ESPRIT APPARELS LTD.

20 October 2025

2. Observation

Observation-02: Crack on the brick wall (Building-1: Production Building).

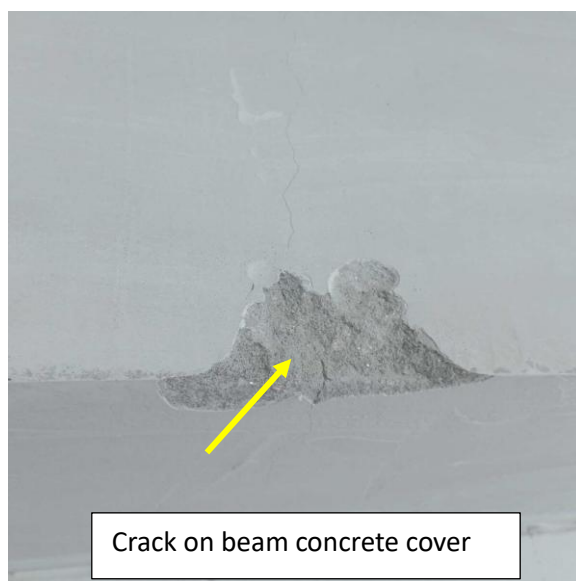
Description: A crack was found on the brick wall on the 2nd-floor toilet area. The building engineer is required to repair the crack on the wall with a suitable method.

4.		Implement remediation work if required.	within 6 months
5.		Implement the load plan.	within 6 months
6.	Crack on the brick wall (Building-1: Production Building).	Repair the crack on the brick wall with a suitable method	within 6 weeks

Observation-04: Possible vehicle impact on the ground floor (Building-1: Production Building).

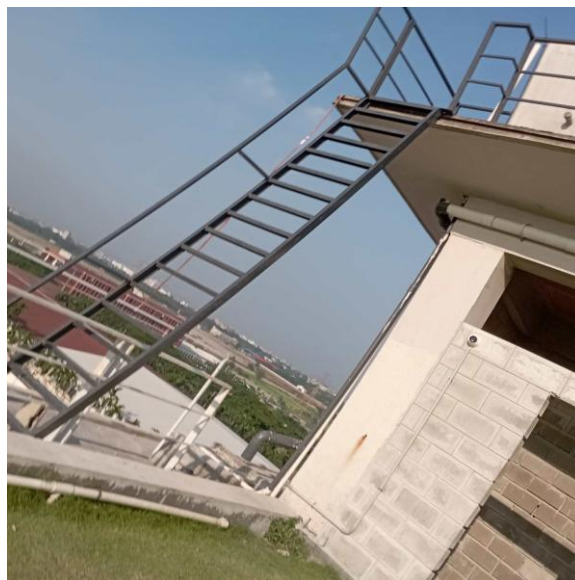
Description: An exposed column was found on the ground floor, prone to vehicle impact. Only an angle was found installed on the column. The building engineer is required to provide an adequate barrier around all exposed columns to prevent vehicle impact.

8.	Possible vehicle impact on the ground floor (Building-1: Production Building).	The building engineer is required to provide an adequate barrier around all exposed columns to prevent vehicle impact.	within 6 weeks

Observation-05: Falling hazard at roof level (Building-1: Production Building).

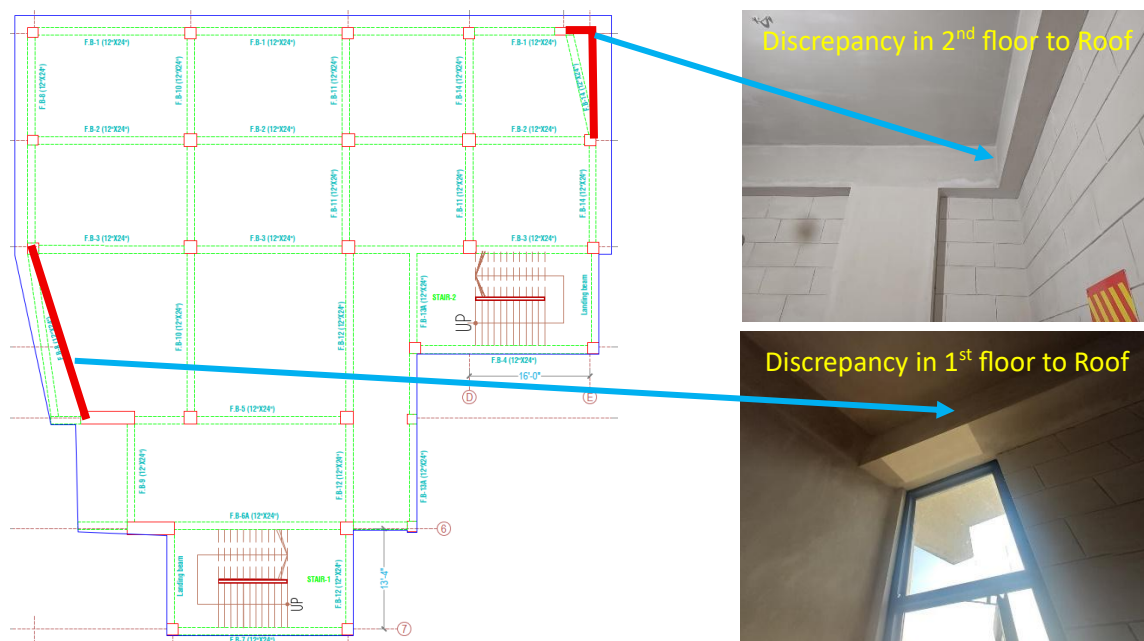
Description: The parapet was missing at the roof level, which could cause a falling hazard. The building engineer is required to provide edge protection to avoid a falling hazard. Also, provide an adequate handrail on the steel ladder.

9.	Falling hazard at roof level (Building-1: Production Building).	The building engineer is required to provide edge protection to avoid a falling hazard. Also, provide an adequate handrail on the steel ladder.	within 6 weeks

Discrepancies in beam layout at typical floor

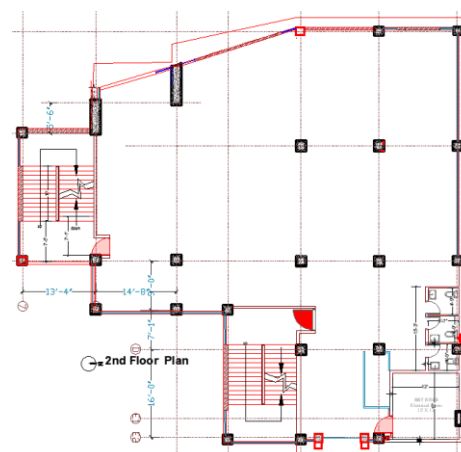
OHW – not shown

Occupancy type – not mentioned

Description: Several discrepancies were identified, including mismatches in beam layout, the overhead water tank not reflected in the drawing, and the occupancy type not specified in the as-built drawings. The building engineer is required to update the as-built drawing as per onsite condition.

12.	Discrepancies in as-built drawing (Building-2: Admin Building).	The building engineer is required to survey the structures and update the as-built drawing as per onsite condition	within 6 weeks

Steel column Layout

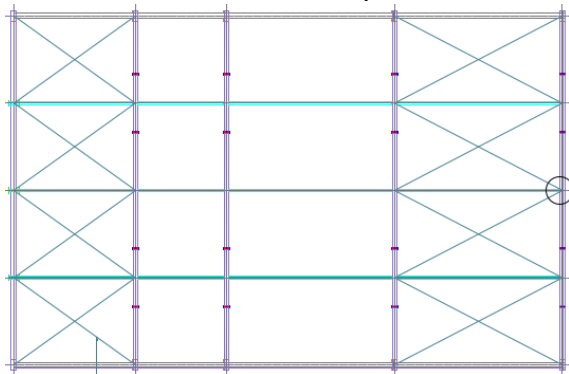
Flange thickness 12.1 mm instead of 14 mm

Description: Several discrepancies were identified, including mismatches in the flange thickness of steel columns, missing roof bracings, and the use of rod bracing instead of cable bracing. The building engineer is required to update the as-built drawing as per on-site condition.

16.		Implement remediation work if required.	within 6 months
17.		Implement the load plan.	within 6 months
18.	Discrepancies in the as-built drawing (Building-3: Utility Shed).	The building engineer is required to survey the structures and update the as-built drawing as per onsite condition	within 6 weeks

Roof Bracing Layout

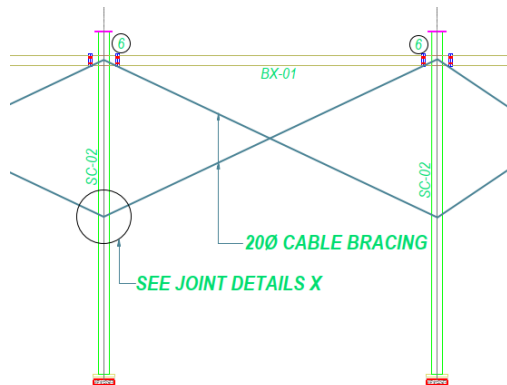
Roof bracing missing

Rod bracing instead of cable bracing

Observation-09: Inconsistencies in the EA report (Building-3: Utility Shed).

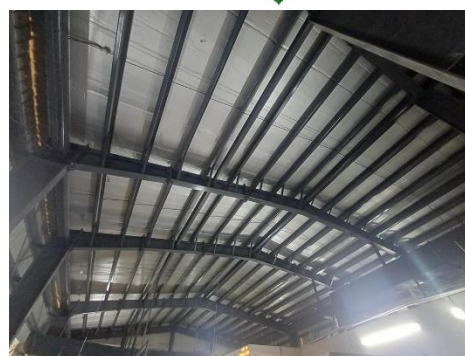
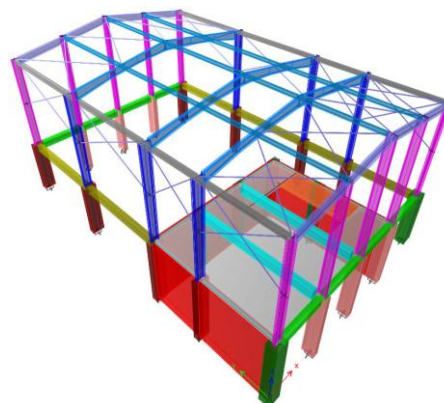
Yield strength was considered 345 MPa in EA, but test results for 8 mm and 10 mm plates were below this value

Roof bracing was considered in the EA, but was not provided at the site

Description: Several inconsistencies were identified in the EA. Yield strength was considered as 345 MPa in the EA; however, test results for 8 mm and 10 mm plates were below this value. Roof bracing was also considered in the EA, but was not provided at the site. The Building Engineer is required to update the EA in accordance with BNBC, address all identified inconsistencies, and submit the revised documents to RSC.

19.	Inconsistencies in the EA report (Building-3: Utility Shed).	The Building Engineer is required to update the EA in accordance with BNBC, address all identified inconsistencies, and submit the revised documents to RSC.	within 6 weeks

Observation-10: Absence of design report. (Connecting Bridge, Building-5: Security Room, Building-6: Medical and Childcare, Building-7: Wastage Shed).

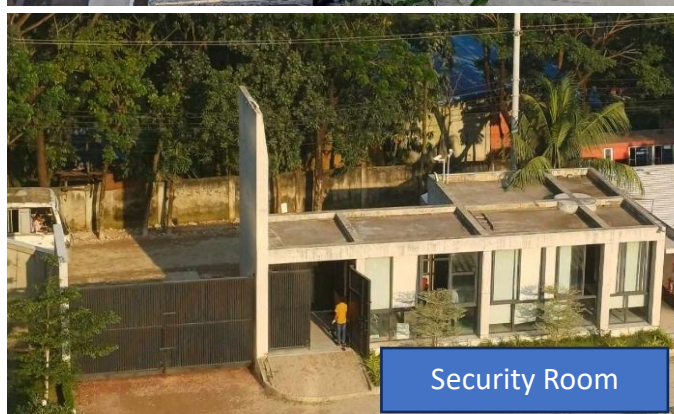
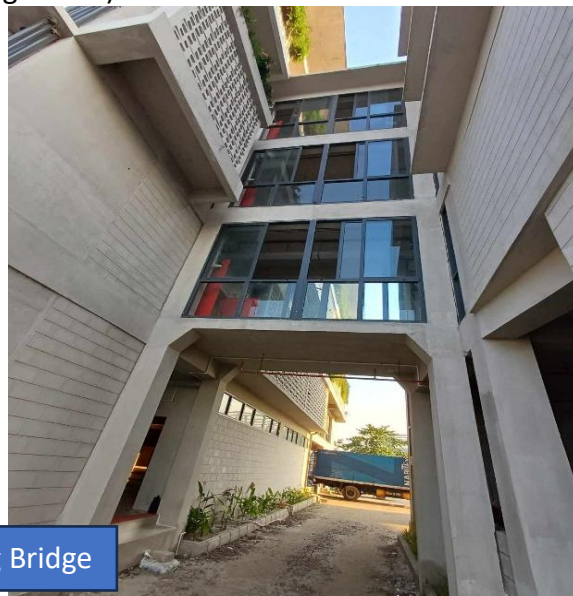
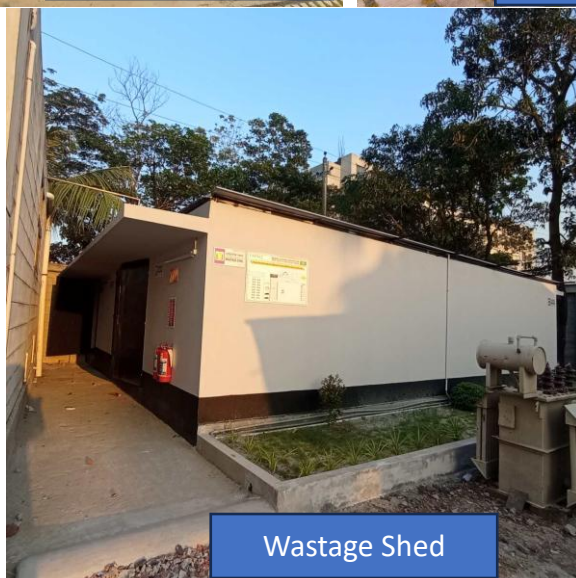
Description: As per BNBC, every building or structure designed shall have its design documents prepared following the provisions of Section 1.9.1. The design report was not available for the Factory Building. The building engineer is required to prepare a design report following BNBC (Part-6, section 1.9.1) and submit it to RSC for review against lateral forces.

10.	Absence of design report. (Connecting Bridge)	The building engineer is required to prepare a design report following BNBC (Part-6, section 1.9.1) and submit it to RSC.	within 6 weeks

20.		Implement remediation work if required.	within 6 months
21.	Absence of design report. (Building-5: Security Room)	The building engineer is required to prepare a design report following BNBC (Part-6, section 1.9.1) and submit it to RSC.	within 6 weeks

22.		Implement the recommendations of the design report.	within 6 months
23.	Absence of design report. (Building-6: Medical and Childcare)	The building engineer is required to prepare a design report following BNBC (Part-6, section 1.9.1) and submit it to RSC.	within 6 weeks

25.	Absence of design report (Building-7: Wastage Shed)	The building engineer is required to prepare a design report following BNBC (Part-6, section 1.9.1) and submit it to RSC.	within 6 weeks

Observation-11: Discrepancies in as-built drawing (Building-8: Boiler Building).

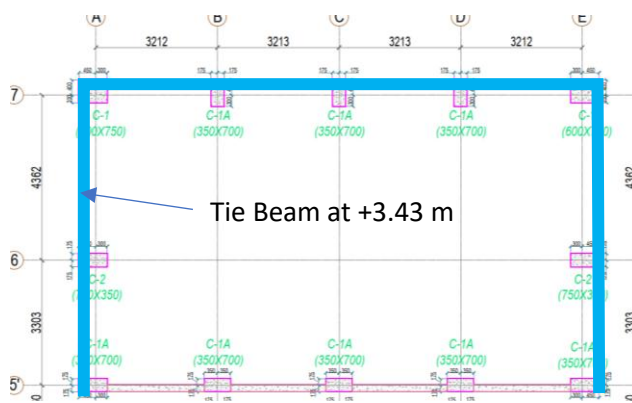
Tie Beam – not shown in drawing

Description: The tie beam layout is missing in the drawings. Additionally, the drawings for the Utility Shed and Boiler Building were prepared together, although the two structures are not connected structurally or architecturally. The Building Engineer is required to prepare separate drawings for each structure and update the drawings as per onsite conditions.

26.		Implement the recommendations of the design report.	within 6 months
27.	Discrepancies in as-built drawing (Building-8: Boiler Building).	The Building Engineer is required to prepare separate drawings for each structure and update the drawings as per onsite conditions.	within 6 weeks
